PLANNING & ZONING COMMISSION

Regular Meeting Agenda
CITY OF PARKVILLE, MISSOURI
Tuesday, March 10, 2026 5:30 PM
City Hall Board Room

- Agenda Item: 6.A
- Proposal: Application for Final Development Plan for Heaterz, a proposed drive-thru restaurant at 7100 Elizabeth St.
- Staff Recommendation: Approval (with conditions)

- Case No: PZ26-03
- Applicant: Michael Letzig, Heaterz KC LLC
- Owners: City of Parkville
- Location: 7100 Elizabeth St, generally located south of Connections Bank in Old Town at Creekside.

B1 front elevation (East)

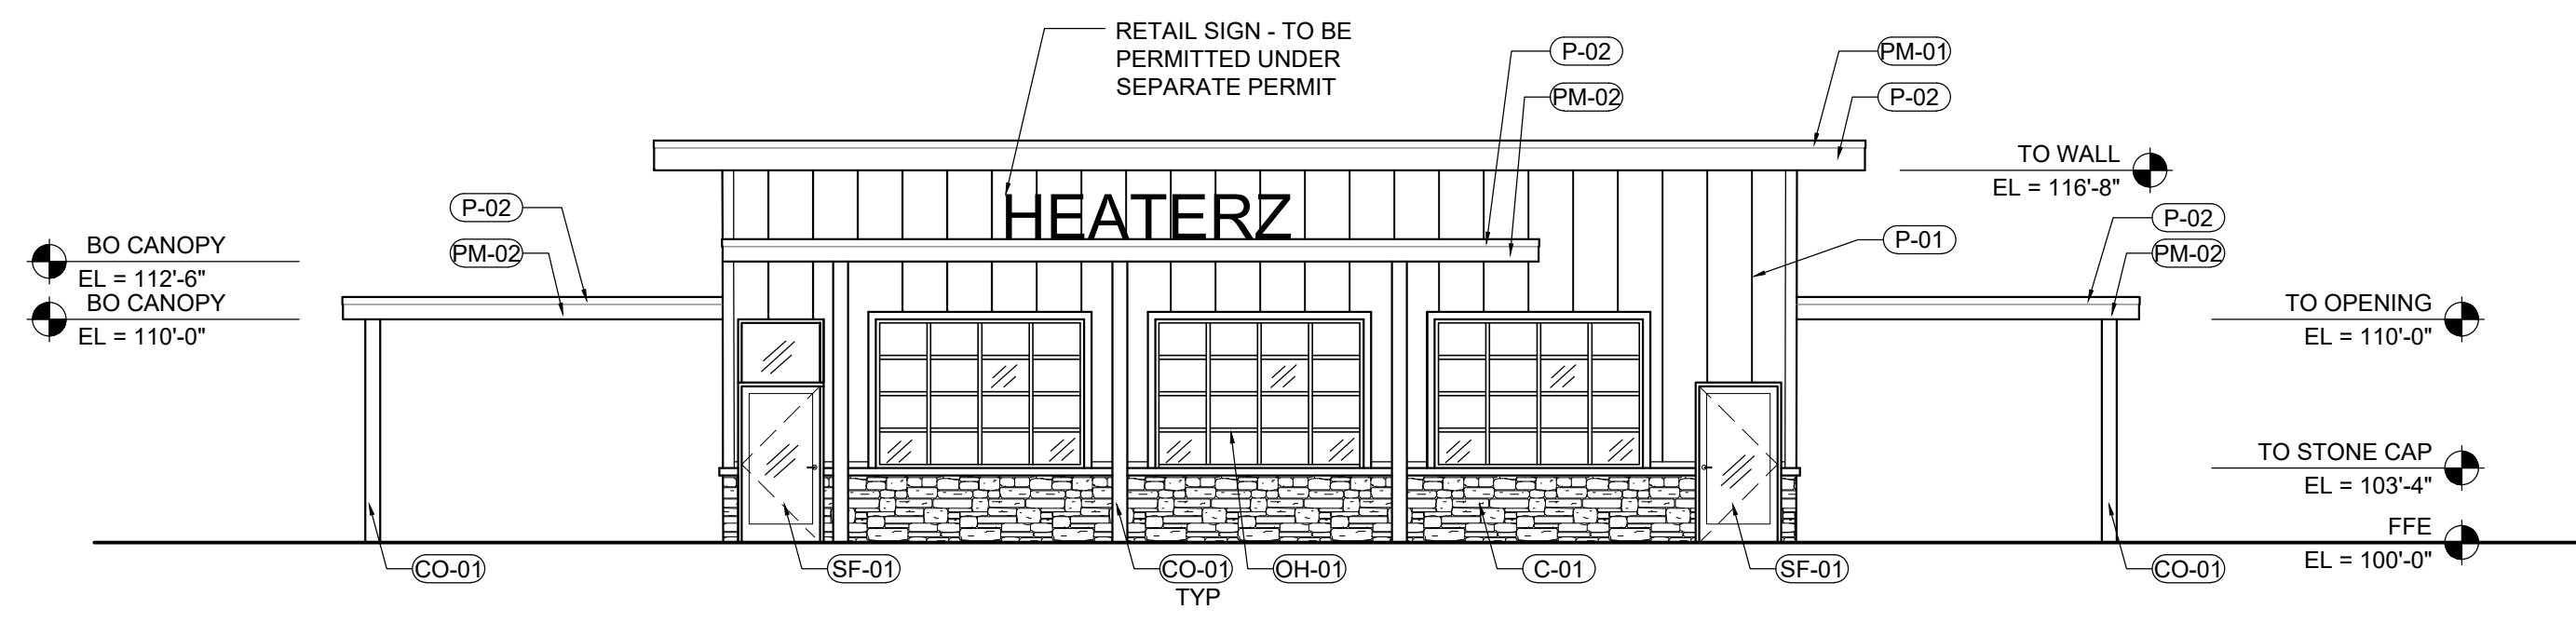
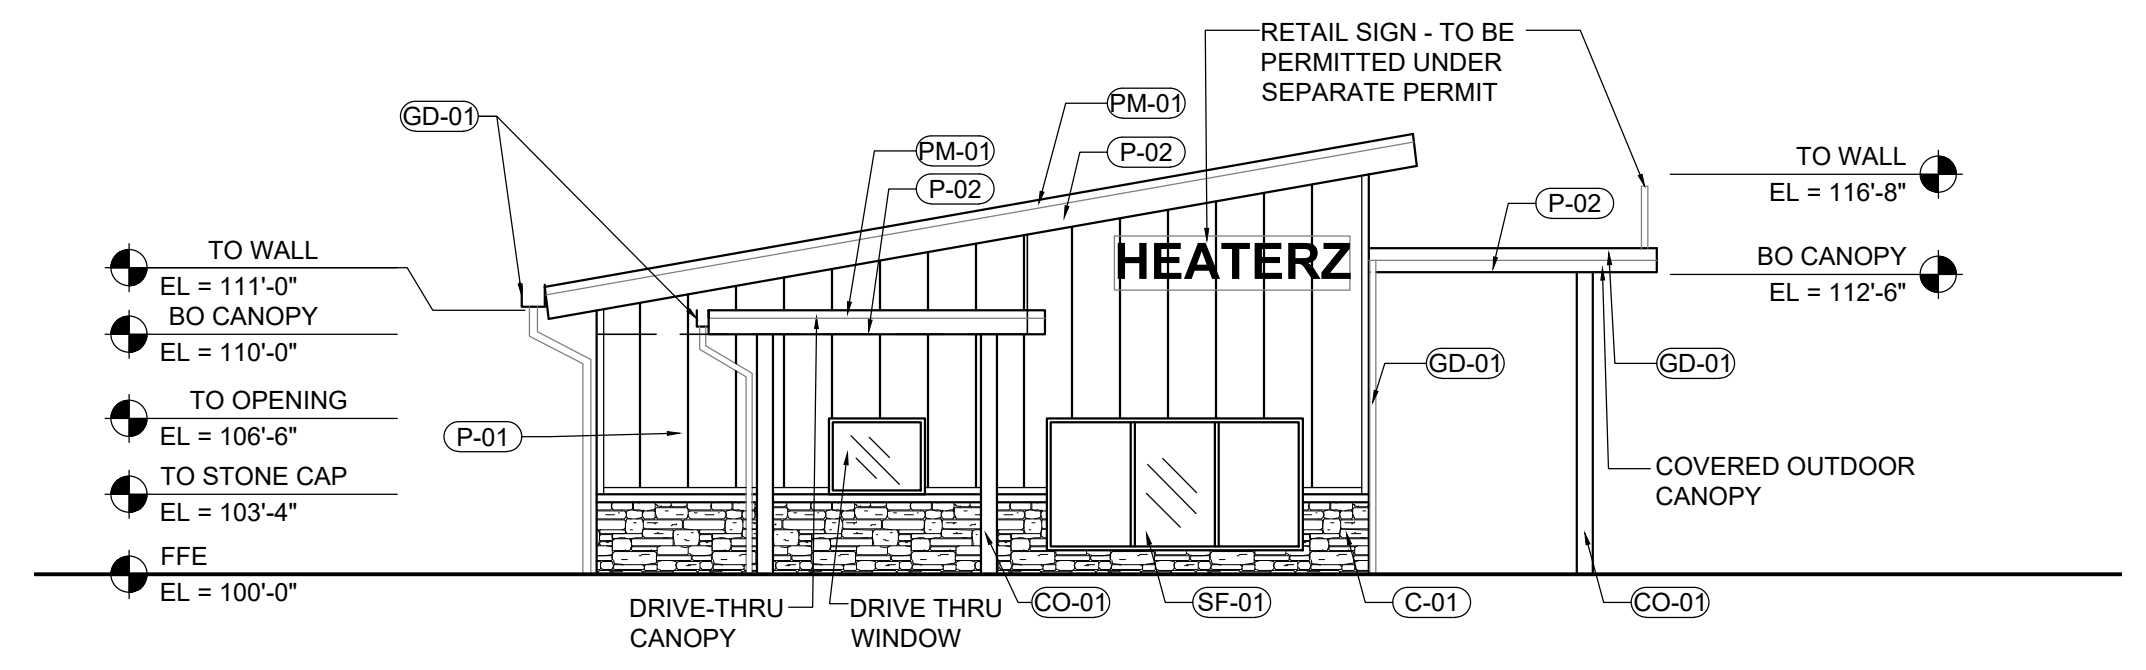
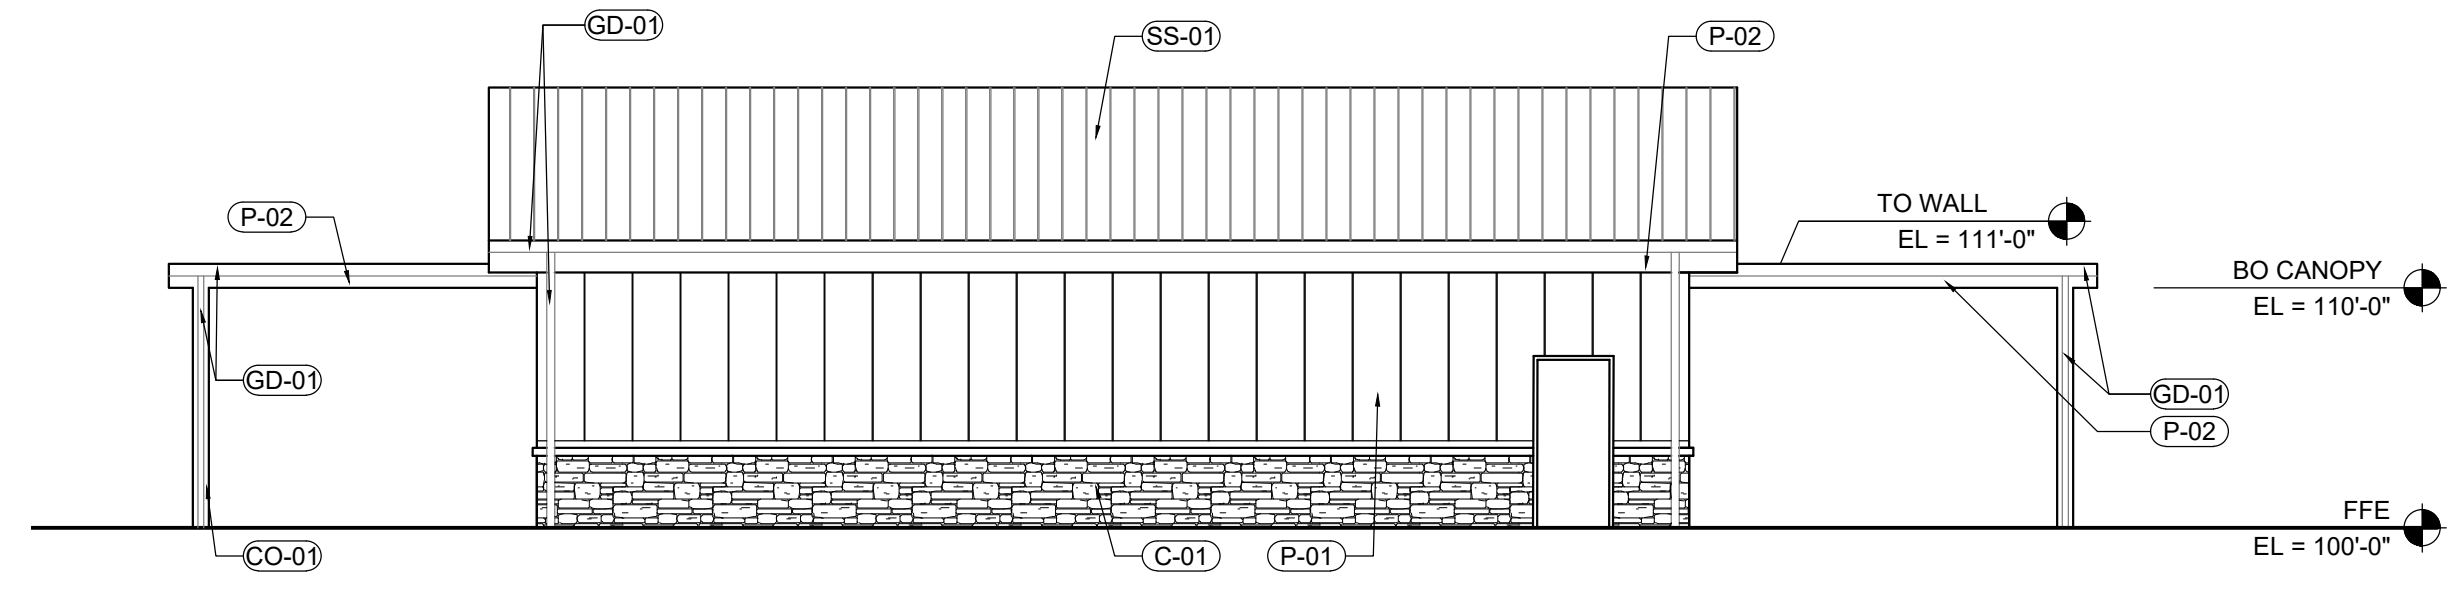
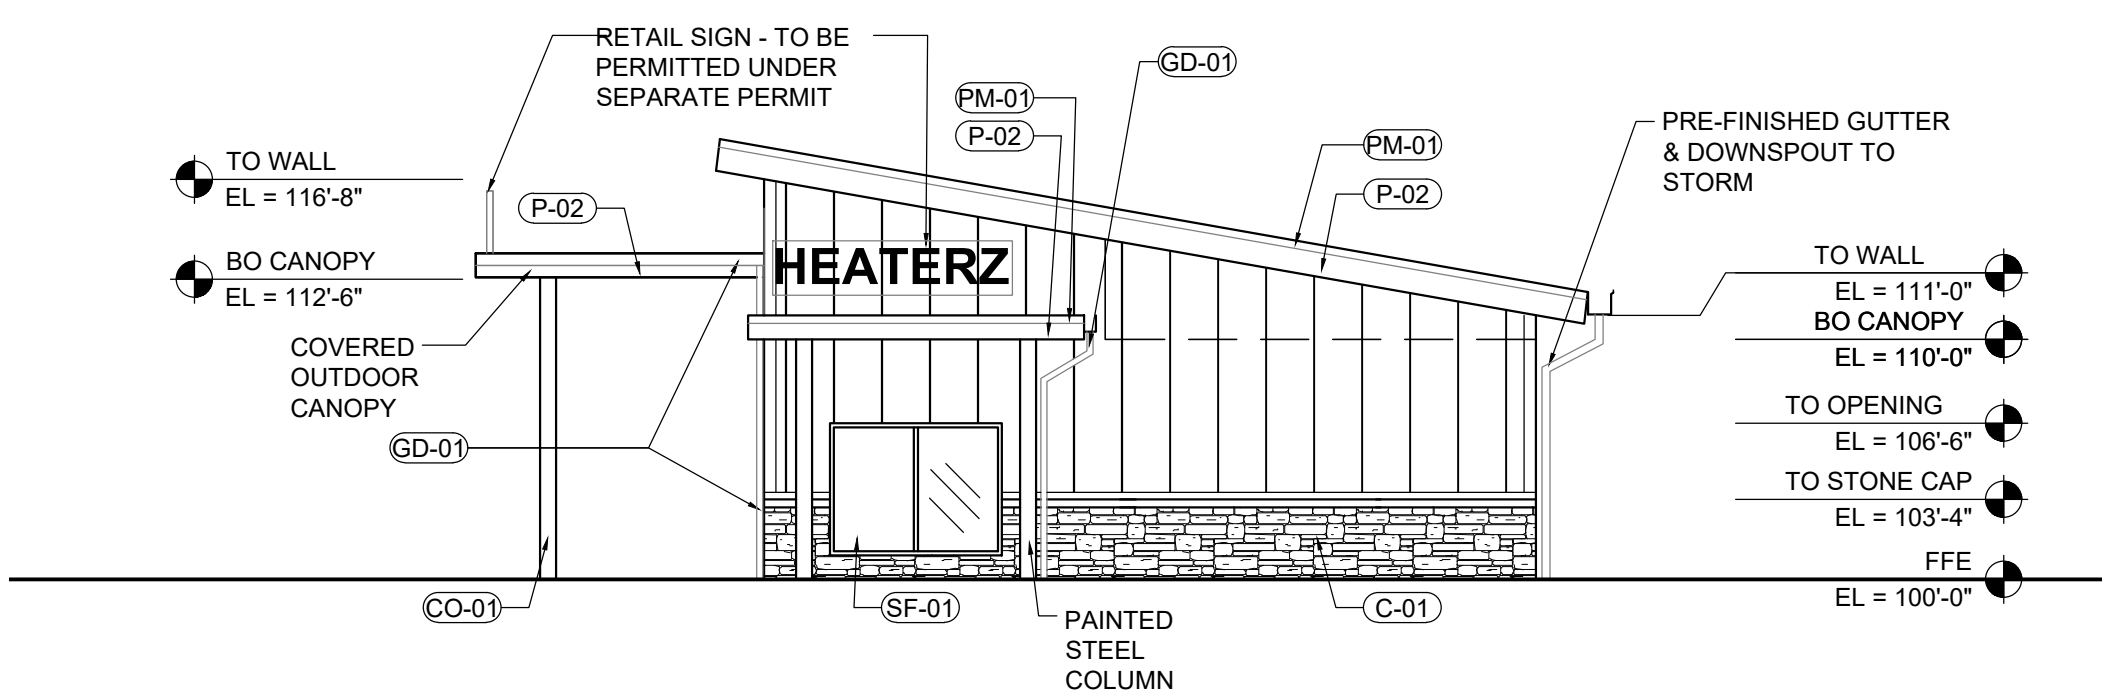
The applicant has indicated the location of wall signage on the proposed elevations (see Exhibit E). Signage requires review and approval through a separate sign permit.

6. All signage requires a separate Sign Permit.
 7. Any other conditions the Planning and Zoning Commission determines are necessary.
